Disputed Sio Silica Responses to DLN Clarification IRs for the Vivian Sand Extraction Project

**By D.M. LeNeveu, Participant DLN
Jan. 30, 2023**

Figure 1. Infrastructure near the Sio Silica extraction area.

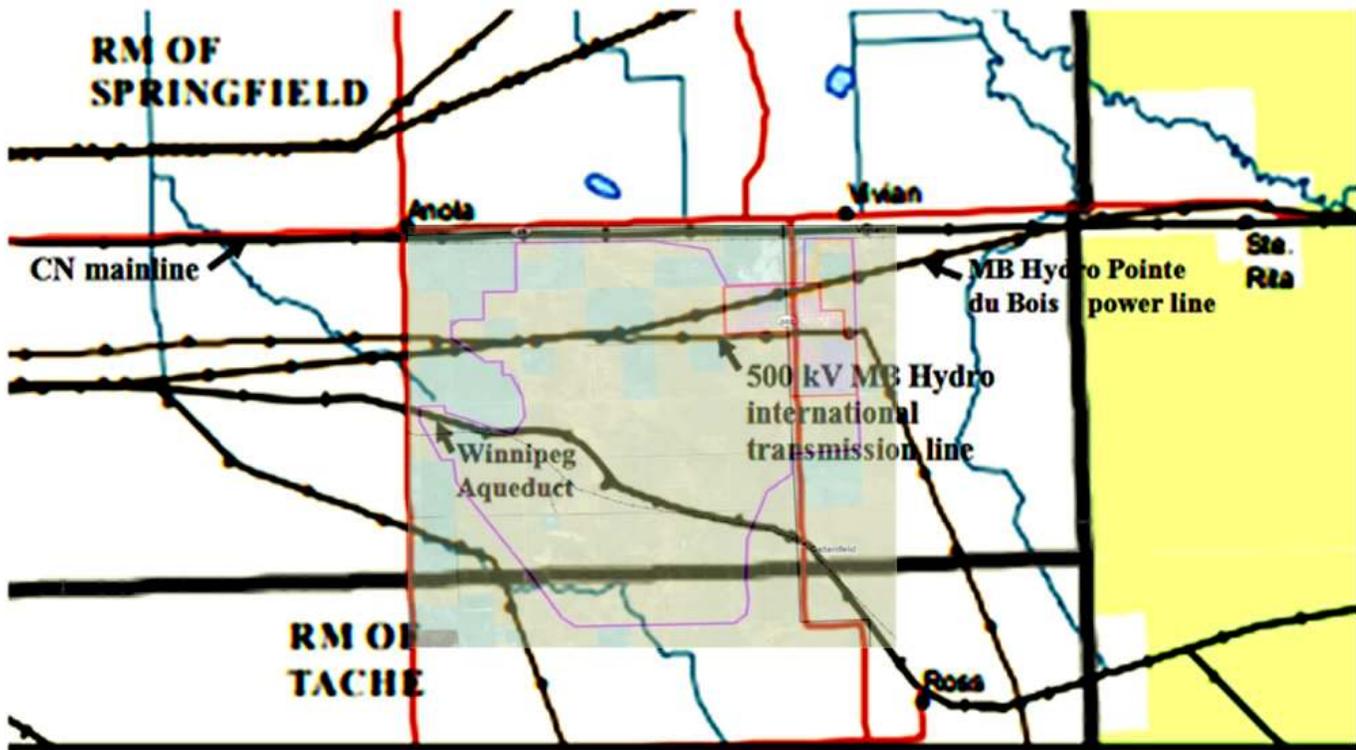
In response to DLN-IR-003c-21-23 concerning the proximity of the extraction to the Hydro transmission lines, *“Sio and Manitoba Hydro have been working towards securing approval and discussions remain*

ongoing.” The revised extraction plan submitted by Sio Silica on January 24, 2023 shows that the extraction location has been moved to avoid extraction near Hydro transmission lines. However slurry line crossing of the transmission lines would still be required. Moving of the extraction site away from the transmission lines is not adequate as approval for slurry line crossing has not been obtained. The transmission lines cross the entire breadth of the Project area. Manitoba Hydro condition for approval such as setback distances for extraction would have a negative impact on the Project by requiring movement of the extraction sites to more environmentally sensitive areas such as settled areas and the Winnipeg aqueduct.

It must be noted that there are two hydro lines that the Sio Silica extractions impinge upon, the Point du Bois line and the international transmission line to Minnesota. The revised extraction plan remains quite close to the international transmission line south of the Point du Bois line. I must assume that permission from Manitoba Hydro has not been obtained for the revised extraction plan and may not be forthcoming. Figure 1 shows the required Sio Silica crossings of infrastructure. The previous first four year extraction plan is shown in figure 1.

I dispute that Sio Silica’s response to the request to obtain Manitoba Hydro’s approval for extraction near the line and slurry line crossing of the line has been adequately answered. The Project and the Hearing must not proceed until approval is obtained from Manitoba Hydro and required conditions of approval are specified.

Figure 2. FAC modelling of the slumping of a backfill pillar in a rock mined cavity⁶
https://itasca-downloads.s3.amazonaws.com/software/applied-examples/BackfillPillar_Ex.pdf

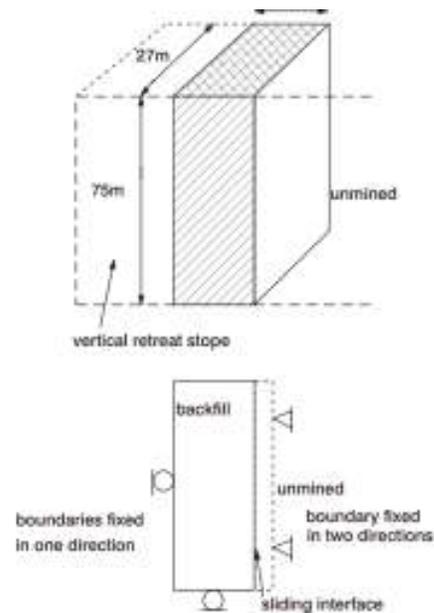
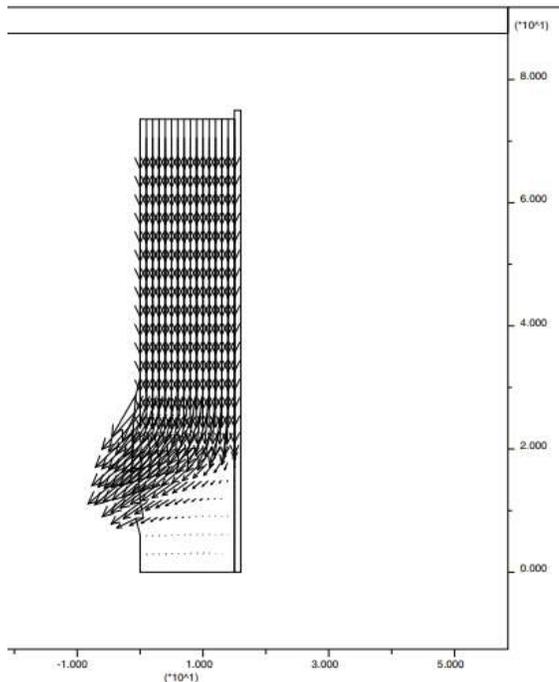
Hollander and Woodbury’s concern on the sand pillar stability has not been adequately addressed by Sio Silica. Sio Silica must give revised cluster spacing for the various sized clusters in the revised extraction plan and describe how the spacing was determined based on the FLAC modelling. An illustration of the FLAC/Slope analysis of a 2D pillar stability for a rock cavity that is being progressively mined is illustrated in figure 2.

It should be noted that the cavity in the illustration is rectangular in shape whereas the cavities from sand extraction would be approximately cylindrical with curved surfaces that would render any 2D approximation more uncertain. Sio Silica should provide a similar illustration for the revised extraction plan including an illustration of the evolution of the sand pillar slumping and the final stable pillar configuration. Such an illustration as shown above need not contain any proprietary information.

Figure 3. Bru 92-3 production well completed July 11, 2021 at a quarry south west of Vivian. Illustration by D.M. LeNeveu was based on the well information report received from Manitoba Groundwater shown on right. Photograph of well Bru 92-3 was reproduced with permission of photographer.

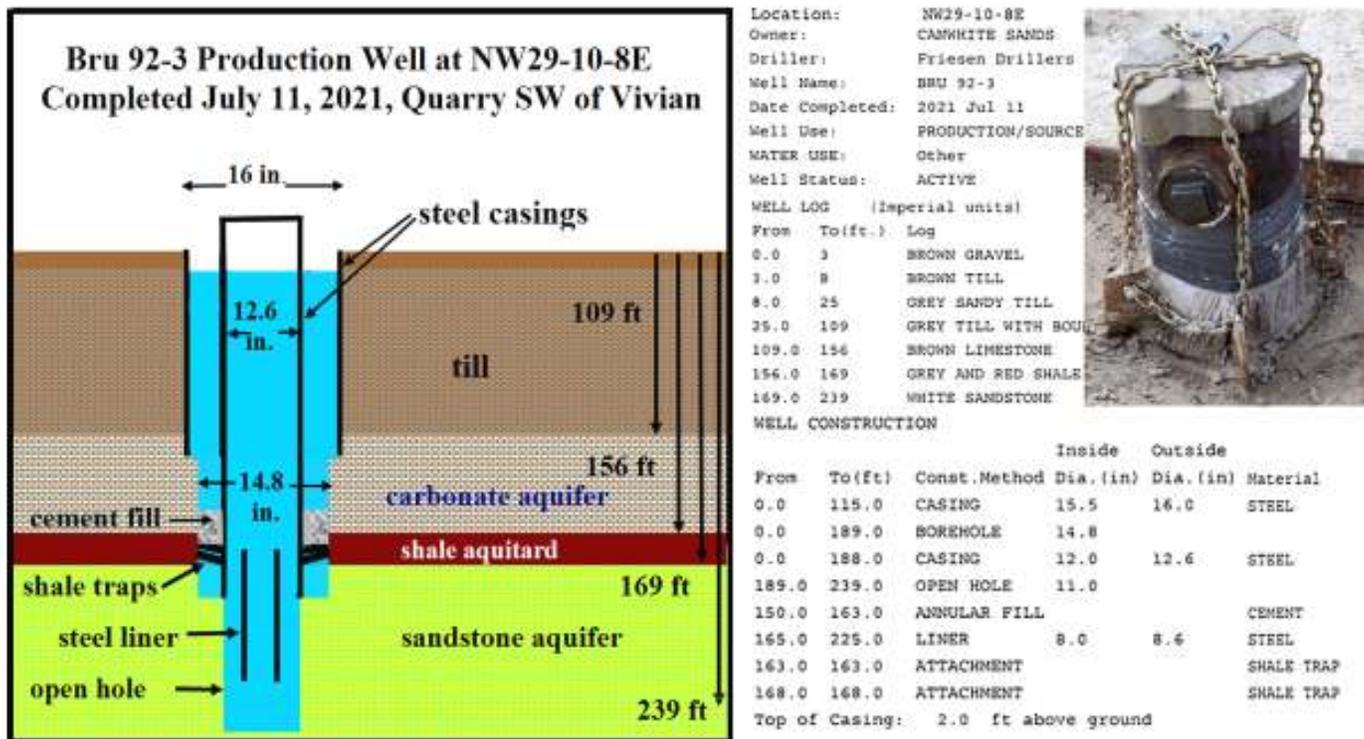
I dispute Sio Silica’s response to DLN-I-009c-9 concerning the open unsealed annulus at surface of Bru 92-3 well. Sio Silica does not directly dispute that the outer annulus for well Bru 92-3 has been left unsealed at the surface. The well information report reproduced and illustrated in DLN-IR-009 figure 1b clearly demonstrates this flaw. The illustration of Bru 92-3 is repeated in figure 3.

Well Bru 92-3 clearly violates the regulation 31(1). Well Bru 92-2 has a temporary shale trap seal at top of the annular space of well Bru- 92-2 as shown in figure 1a of DLN-IR-009. Bru 92-2 also violates the regulation that the space above 6 m must be filled continuously with grout to the established ground surface.

Sio Silica has clearly violated regulation 31(1) for wells Bru 92-3 and Bru 92-2. The open annular spaces for Bru 92-3 and Bru 92-2 connect directly into the carbonate aquifer allowing any surface contamination and fecal matter to enter into the carbonate aquifer. If this has occurred in a small number of test extraction wells it is very likely to occur repeatedly in production when over 300 wells are to be drilled per year. I request that Sio Silica confirm that the surface sealing of wells Bru 92-2 and Bru 92-3 violate the regulations of the Act and immediately properly seal these wells. Strict inspection and enforcement would be required for any further wells drilled by Sio Silica especially if Sio Silica is ever allowed to proceed to production. There are numerous other instances of improper well sealing of Sio Silica wells in the past that have been documented with photographs as shown in the public comments by T. Bell for the extraction project. Sio Silica has claimed without evidence that such unsealed wells were due to vandalism. In fact some of the wells left open in the past had partially welded seals on the pipes extending out of the ground. A vandal would have required a steel cutting torch to open such seals. Sio Silica has demonstrated that they cannot be trusted to seal wells properly. On this basis alone the Project must not be allowed to proceed.

Figure 4. Google Earth image of original Sio Silica extracted sand piles and photographs of the Sio Silica silica sand piles taken June 7, 2020 (left) and Nov.14 2020. *The photographs are reproduced with the permission of the photographer.*

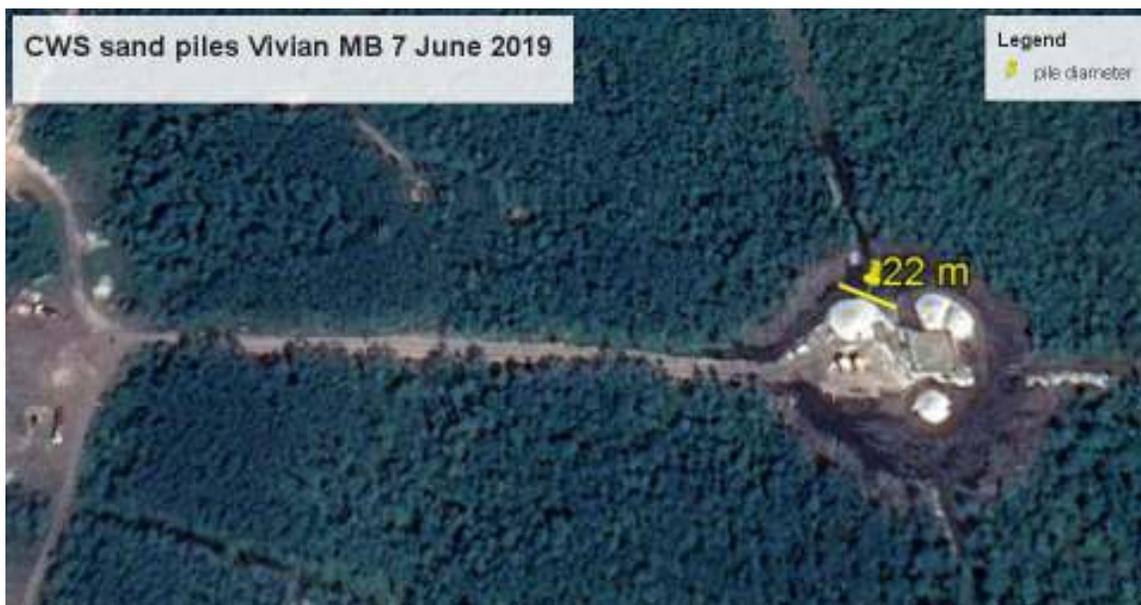
Sio Silica states; “The sand pile from which the Bru 94-3 sand sample was taken was covered by tarp and not exposed to weather for an extended period of time.” This statement is false as shown by the evidence given in my public comments for the processing facility of the uncovered sand piles south of Vivian shown in figure 17 of the public comments report. The sand for the Bru 94-3 sample was extracted from wells at Vivian in June of 2019. The tarp was placed over the exposed sand piles following a complaint of June 28, 2020 to Manitoba Workplace Safety and Health that ATV operators and passers by were being exposed to silica dust from the sand piles. The photographs below confirm these statements.

Figure 4. CWS 24 year project area overlaid on the map of the extent of the Carman sands (green speckle area) south of Vivian MB.

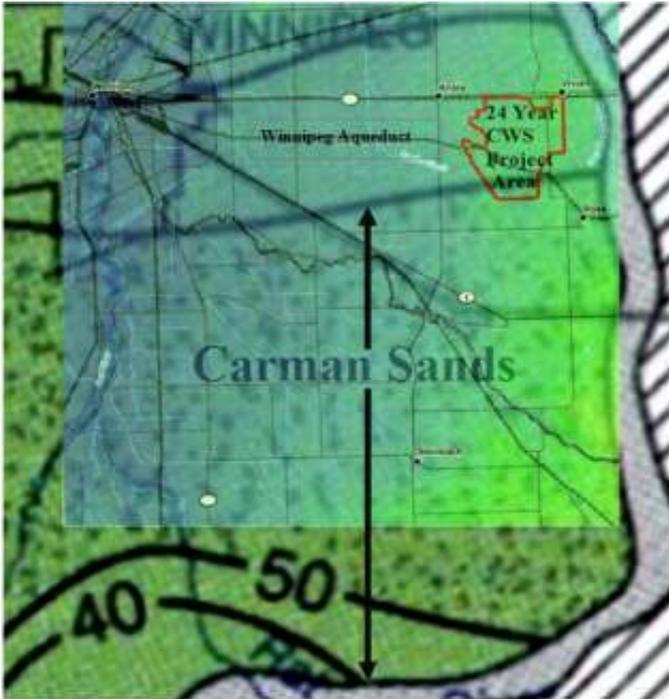
I dispute the Sio Silica response to DLN-IR-011c-15 concerning references to the sand from the Wanipigow Project. Sio Silica claims that the sand at Wanipigow is from a different geological member although the sand was laid down in the same Ordovician age under the same environment at both locations. Sio Silica repeatedly claims that the sand near Vivian is from a separate Carman sand member. Sio Silica ignores the evidence I presented in the public comments for the extraction project that the Carman member is further south as shown by the Energy and Mines Bedrock Geology Compilation Map Series shown again below.⁹

Sio Silica claims the shale at Vivian is more weathered than at Wanipigow even though some of the sand outcrops at Wanipigow and the shale is therefore near surface and much more prone to weathering than at Vivian. Sio Silica continually quotes they are following industry standard methods that may be from other projects that are inapplicable. Sio Silica uses information from other projects if it supports their proposal. To properly evaluate this Proposal, information from other applicable Projects or situations can and must be used since so little information is supplied for this Project and this Project has not yet been implemented. Using information and data from other sources is standard and accepted practice. When I participated in the Seaborn Panel Environmental Review of the Canadian Concept for Canada’s Nuclear High Level Nuclear Waste we continually used applicable information from other projects such as the Swedish SKB nuclear waste disposal project.¹⁰ I therefore claim that results from Wanipigow are relevant and must be considered.
